ADDENDUM NO. 3

Elm Road Elementary School – Classroom Addition

Penn High School Instructional and Activity Space Addition

Project No. 223211.00/223213.00

ITEM NO. 4. <u>PENN HS – DRAWING SHEET – PL.11:</u>

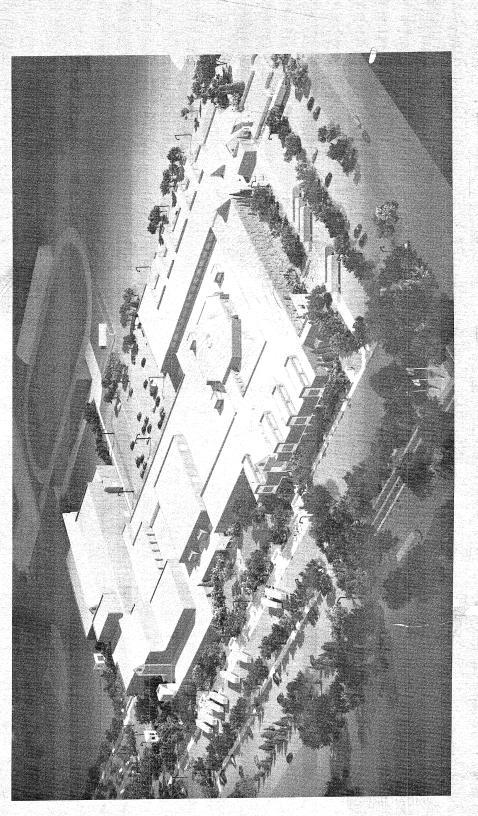
A. Foundation Plan 1-PL11, Add the following note: "Refer to existing 1987 Construction Drawings C6 and C7 for rim elevations for the sanitary inverts to the north and south of the addition."
